28 Redington Road,
London NW3 7RB

Basement Impact Assessment
Audit

For
London Borough of Camden

Project Number: 12336-98
Revision: D1

Figure 1 – Extract from "Map of basements granted PP around 28 Redington Road" (Camden Council)

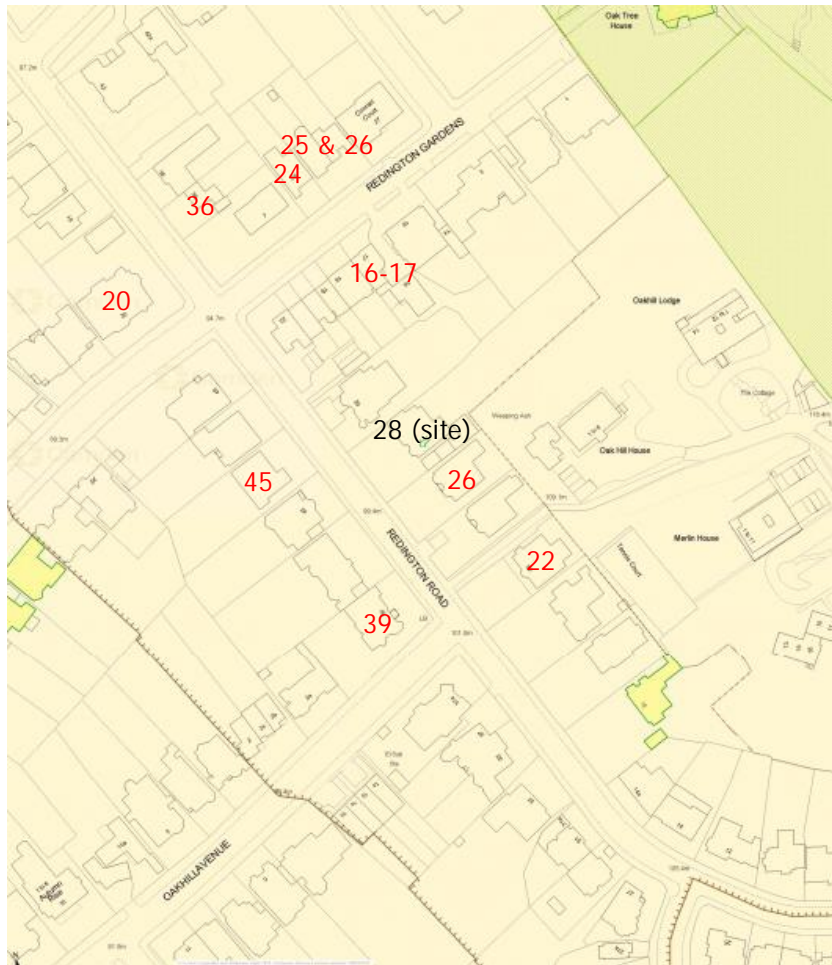
- 4.12. As noted in Figure 1, there are numerous properties within the vicinity of No. 28 Redington Road that have an existing basement. One of these is No. 26 Redington Road where planning permission was granted to lower an existing basement level further. The scheme was consented in 2013 and it is understood that construction works should have been now completed. There are another 9 properties close to site with completed single storey basements.

- 5.7. There are numerous properties within the vicinity of No. 28 Redington Road with basements. One of these is No. 26 Redington Road where planning permission has been granted to lower an existing basement level in 2013. Consideration must be given to the localised and cumulative impacts of the basement proposals on groundwater flows.
